Access Compliance Report

Public Rights-of-Way

(Pedestrian Signals)

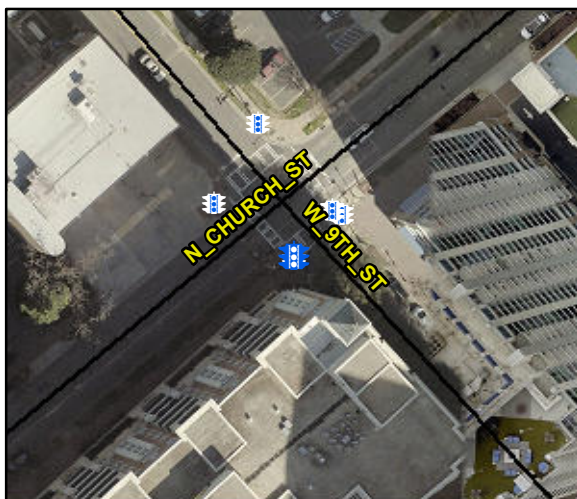
Surveyor Notes: TXT HT 5/16

PROW/ADA: R410.6, R404.2, R406.2, R404.3

Possible Solutions: Remove & Replace Sign. Provide Push Button Extension. Remove and Replace Clear Space.
